# DISCRETIONARY REVIEW ANALYSIS

**Record No.:** 2020-002743DRP-02  
**Project Address:** 1555 Oak Street  
**Permit Applications:** 2020.0226.5525 & 2020.0923.4827  
**Zoning:** RM-2 [Residential Mixed, Moderate Density]  
40-X Height and Bulk District  
**Block/Lot:** 1222 / 028A  
**Project Sponsor:** Charles Perry  
Charles Perry Associates  
231 41<sup>st</sup> Avenue  
San Mateo, CA 94403  
**Staff Contact:** David Winslow – (628) 652-7335  
[david.winslow@sfgov.org](mailto:david.winslow@sfgov.org)

**Recommendation:** Take DR and Approve with Conditions

# Proposed Tandem Garage Parking - Nonfunctional

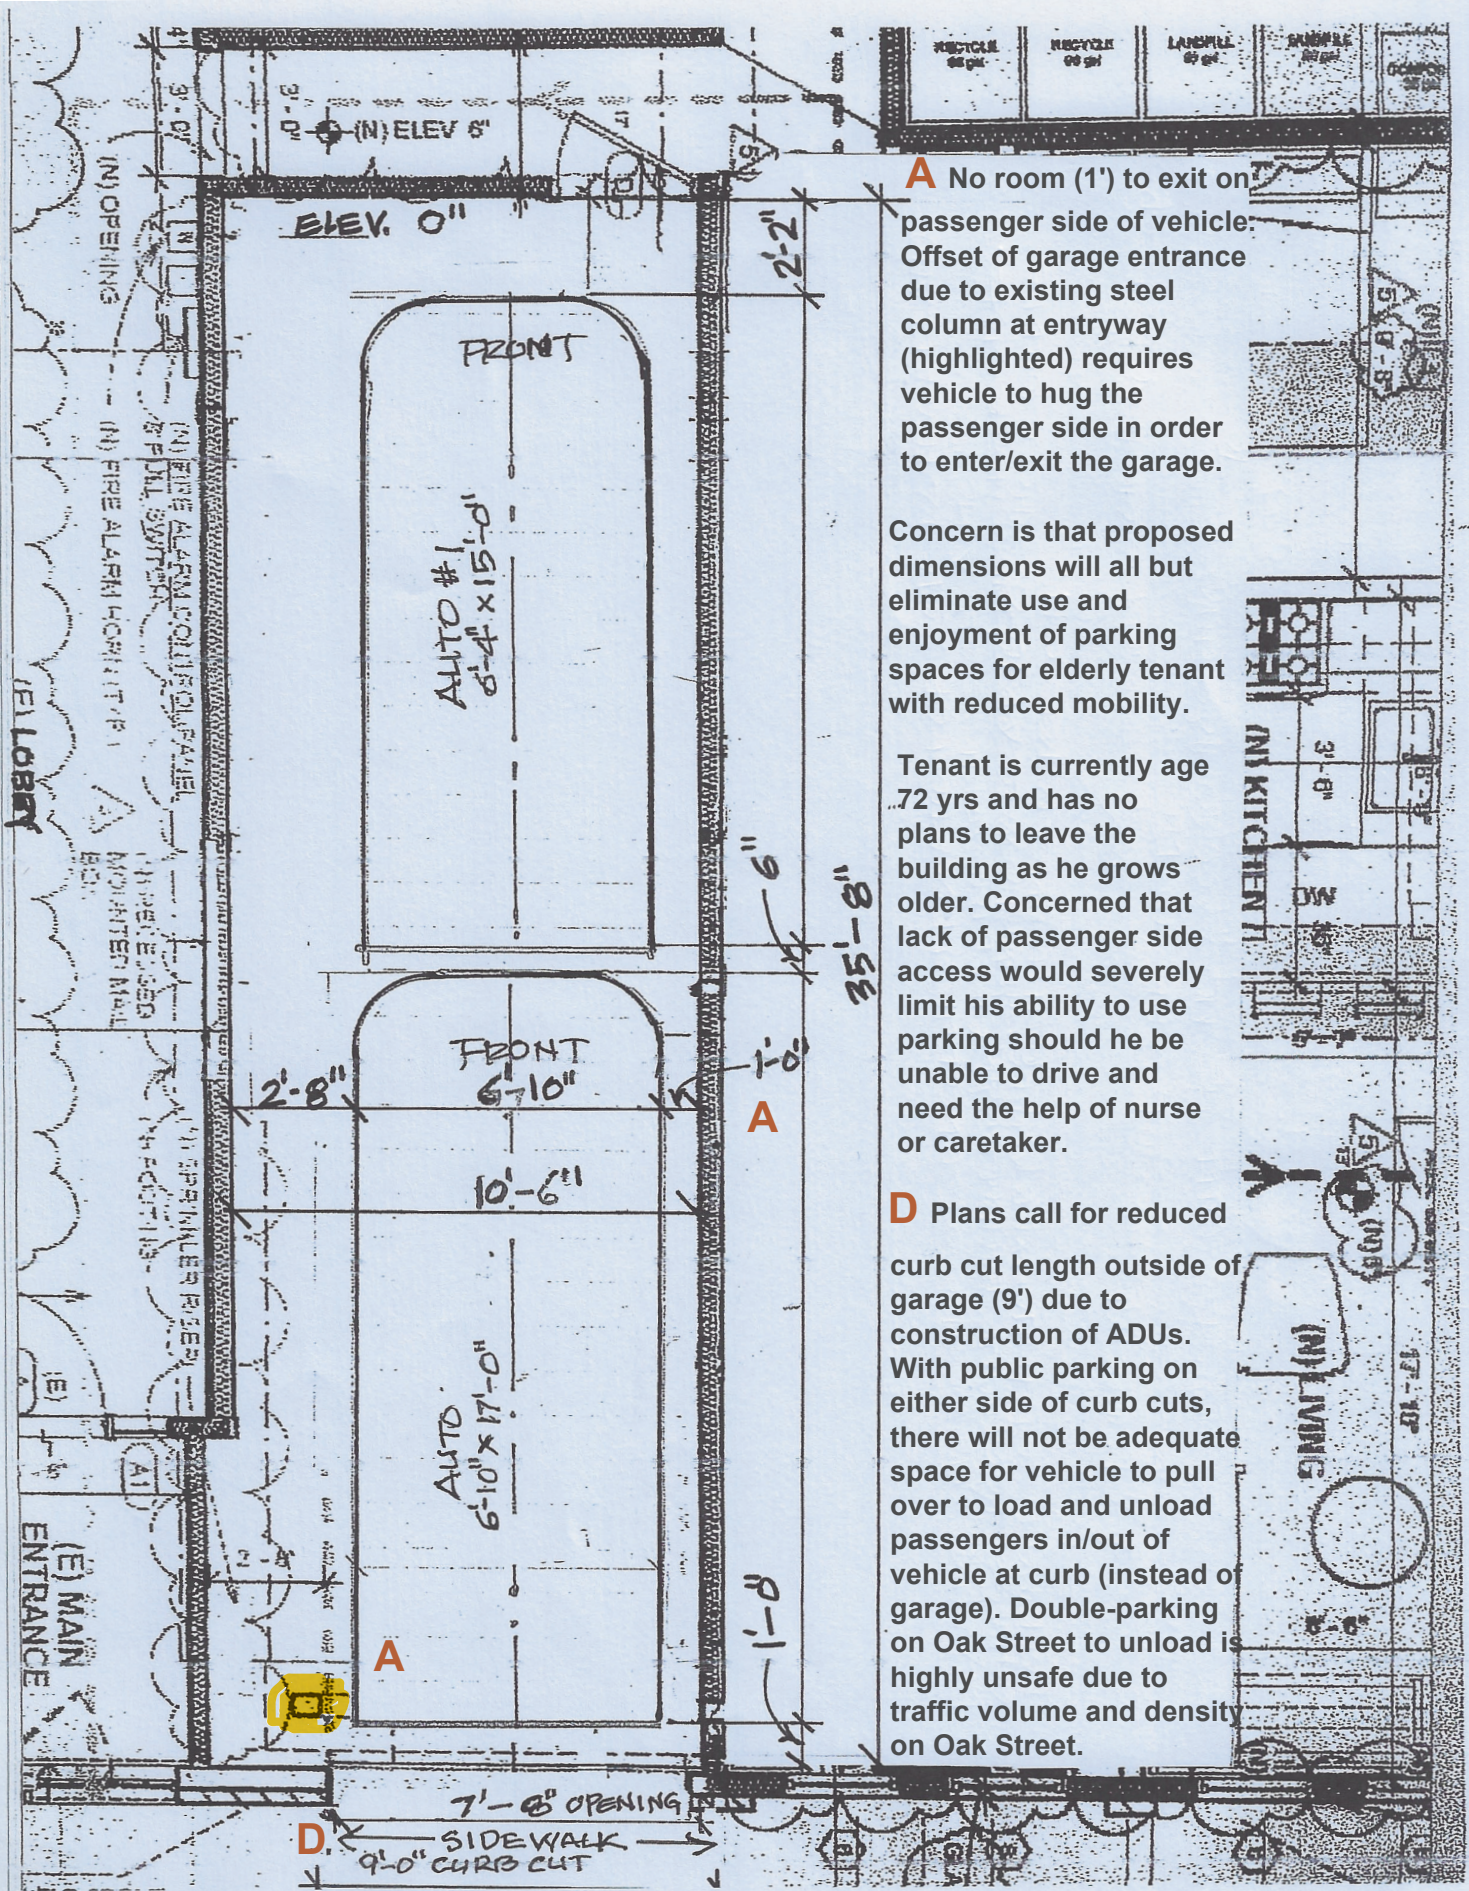
**A** No room (1') to exit on passenger side of vehicle. Offset of garage entrance due to existing steel column at entryway (highlighted) requires vehicle to hug the passenger side in order to enter/exit the garage.

Concern is that proposed dimensions will all but eliminate use and enjoyment of parking spaces for elderly tenant with reduced mobility.

Tenant is currently age 72 yrs and has no plans to leave the building as he grows older. Concerned that lack of passenger side access would severely limit his ability to use parking should he be unable to drive and need the help of nurse or caretaker.

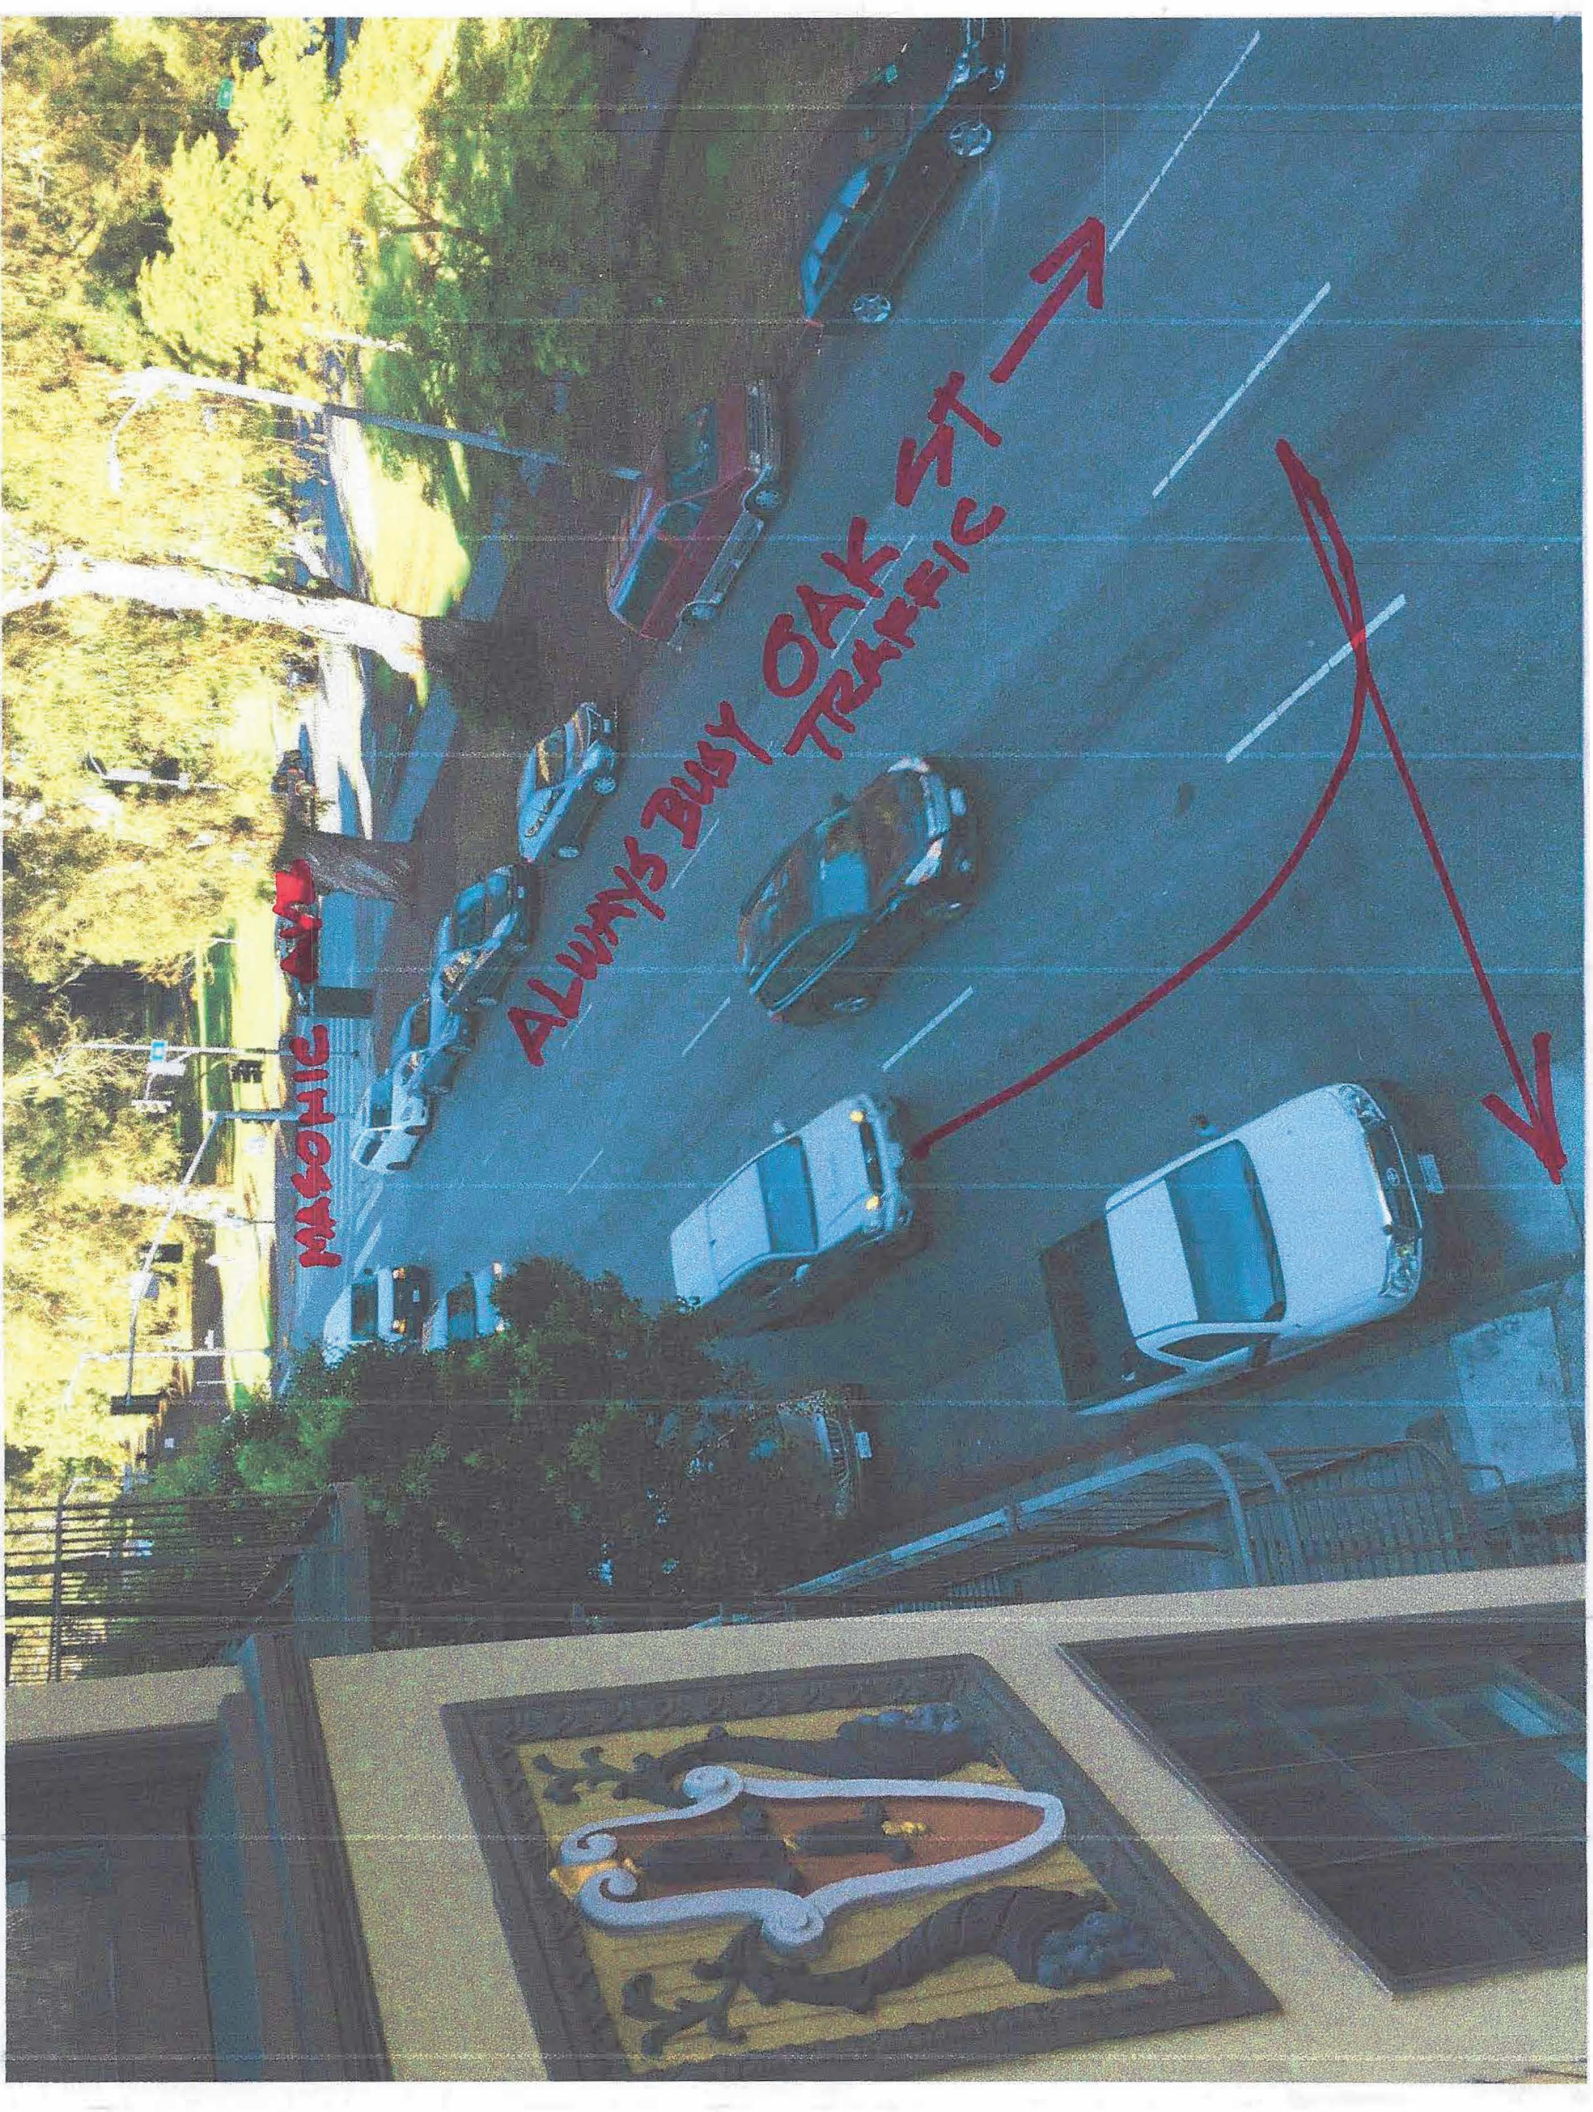
**D** Plans call for reduced curb cut length outside of garage (9') due to construction of ADUs. With public parking on either side of curb cuts, there will not be adequate space for vehicle to pull over to load and unload passengers in/out of vehicle at curb (instead of garage). Double-parking on Oak Street to unload is highly unsafe due to traffic volume and density on Oak Street.

# Dimensions requested by tenant for functional garage space

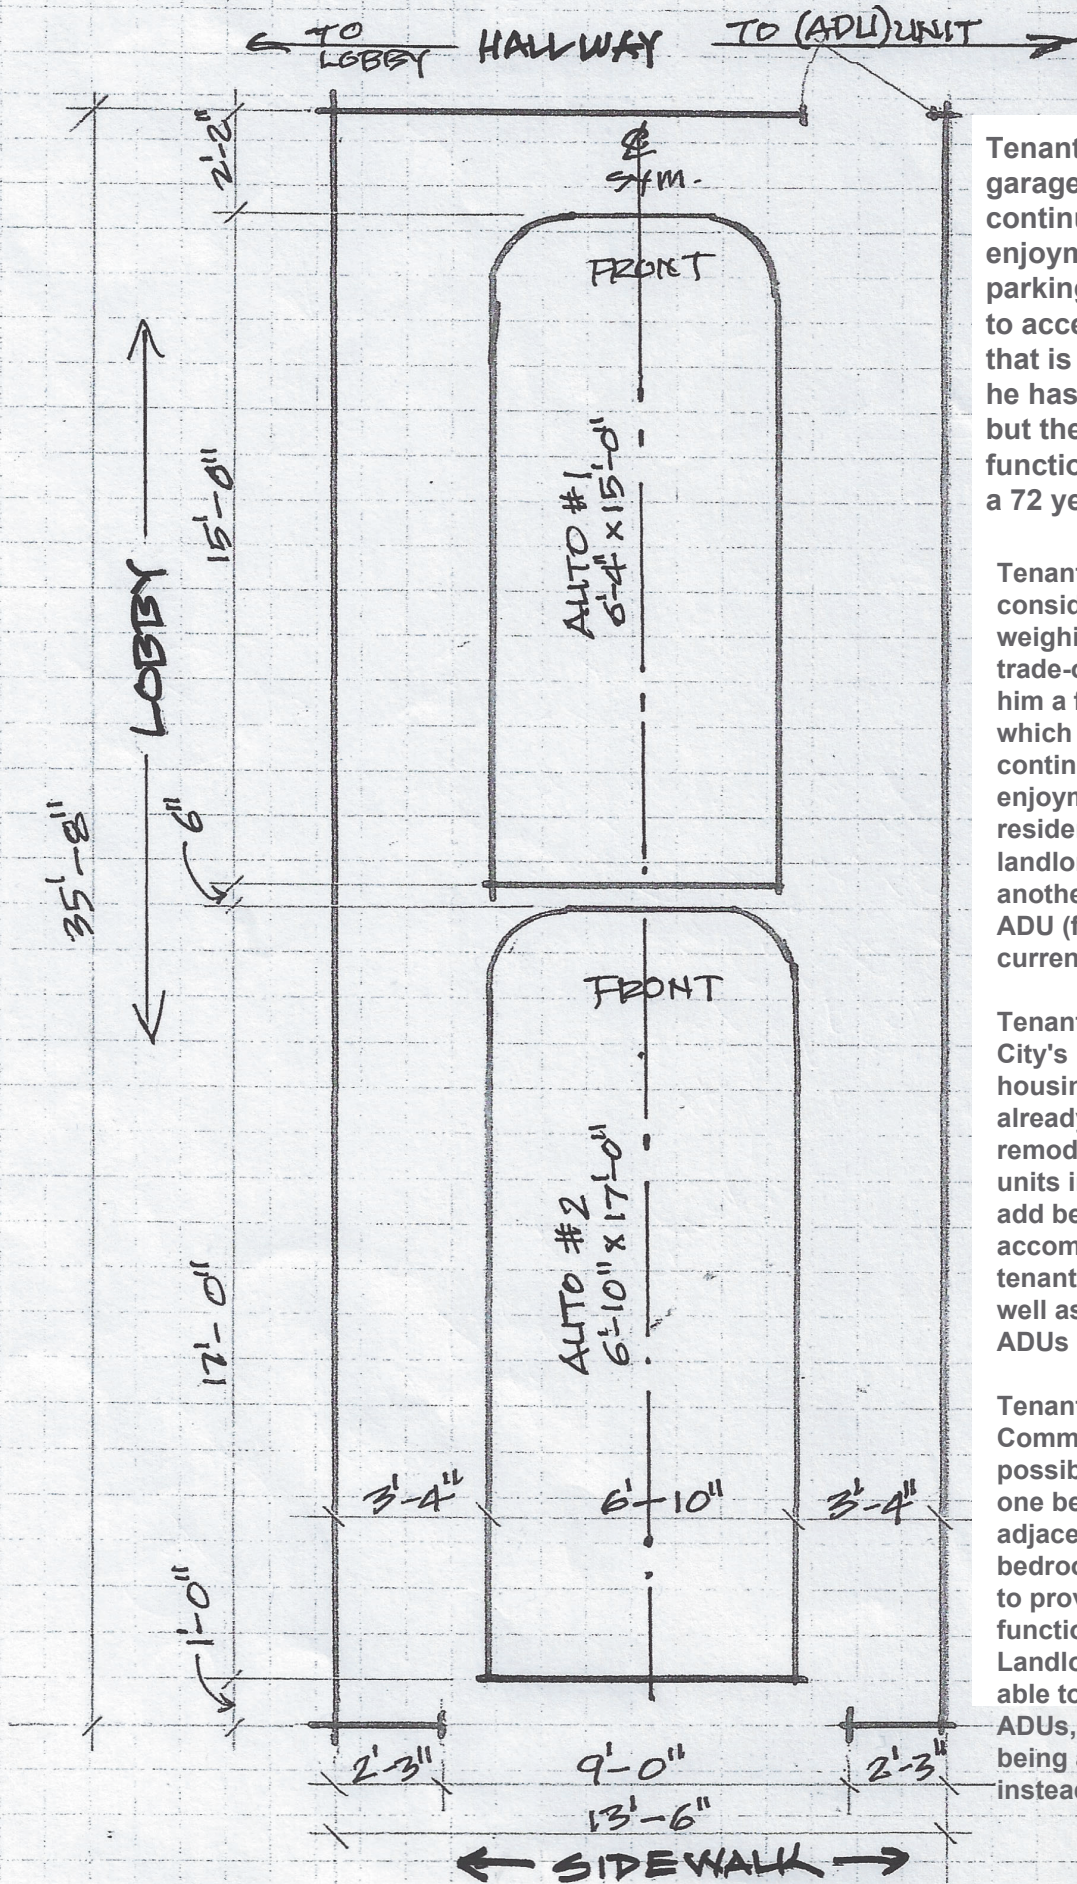
Tenant requests pictured garage dimensions for continued use and enjoyment of functional parking. Tenant is willing to accept garage space that is smaller than what he has had for 44 years, but the space needs to be functional to his needs as a 72 year old man.

Tenant requests fair consideration be given to weighing the potential trade-offs of providing him a functional garage, which is integral to his continued use and enjoyment of his residence, and allowing landlords to squeeze in another two bedroom ADU (for a total of 3) into current ground floorplan.
